Summary of Changes from BSIM-BULK 107.1.0 to BSIM-BULK 107.2.0:

BSIM Group, IIT Kanpur, UC Berkeley

BSIM-BULK 107.2.0_beta0_1

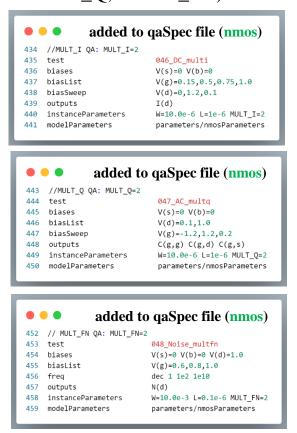
5. 2024enh1 (ADI): Added additional parameters to the parameter set in nmos and pmos PARAM_Check files.

- nmosPARAM_Check and pmosPARAM_Check files are supposed to test all the parameters set to their default values.
- In BSIM-BULK107.2.0 beta 1, 24 parameters were not present in the parameter set of the above two files.
- In BSIM-BULK107.2.0 beta 2, including the parameters newly added, the following 34 additional parameters were added to the nmosPARAM_Check and pmosPARAM_Check files:
 MULT_I, MULT_Q, MULT_FN, ALPHA1, ALPHA2, ALPHADR1, ALPHADR2, DRII3, DRII4, CMD1, CMD2, CMS1, CMS2, BETA1, BETA2, BETA3, ALPHA0R, BETA0R, SPQBACV, NOIA3, MPOWER, QSREF, SPFN, RDLCWCV, ALPHA3, ALPHA4, ALPHADR3, ALPHADR4, DREXP, PTWGHVII, PTWGHVIII, PSATXHVII, DSMOOTH and CVSLOPE.
- These were set to default values.
